WATER QUALITY MEMORANDUM

Utah Coal Regulatory Program

2009 3rd Quarter Water Monitoring, Hidden Splendor Resources, Inc., Horizon

Mine, C/007/0020-WQ09-3, Task ID #3384

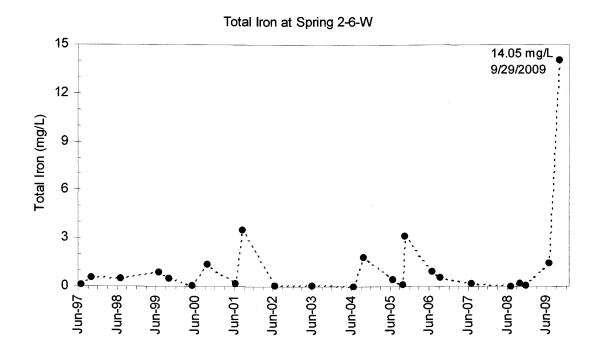
The total iron concentration reported for spring 2-6-W on 9/29/2009 was 14.05 mg/L, which exceeds the average measured concentration at this site by greater than two standard deviations. The previous maximum total iron concentration reported for this spring was 3.5 mg/L during third quarter 2001. As shown in the plot below, the total iron result for third quarter 2009 appears to be anomalously elevated.

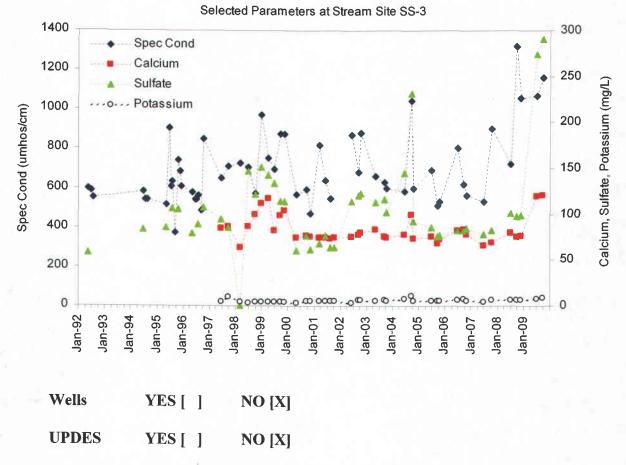
Specific conductance, sulfate, dissolved calcium and dissolved potassium were elevated by greater than two standard deviations above average values for stream site SS-3 during third quarter 2009. The cation-anion balance was acceptable for the third quarter 2009 stream SS-3 sample analysis. Reported values for specific conductance, sulfate and dissolved calcium have been highly variable, as shown in the graph below. The timeseries data suggest that specific conductance may be increasing at site SS-3.
